### Installation Tip for WPS3025 Coolant Pump for BMW 135i, 335i, 535i, 640, 740i from model year 2007

**Fig. 1**

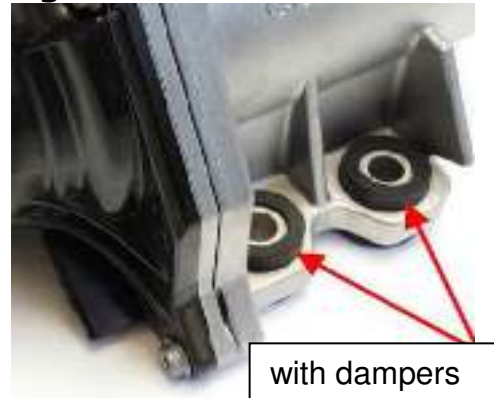
The electric coolant pump which has been removed may have prefitted dampers at the three screw-fastening points (Fig. 1). The new WPS3025 coolant pump does not have these. The old fastening bolts are not suitable for reuse.

The vehicle manufacturer has changed the coolant pump over to this new design without dampers (Fig. 2).

The aluminum bolts which have been removed (M8x36) must not be reused, but must be replaced with shorter steel bolts (M8x26).

Please use the MS50 mounting set (Fig. 3) which is available separately.
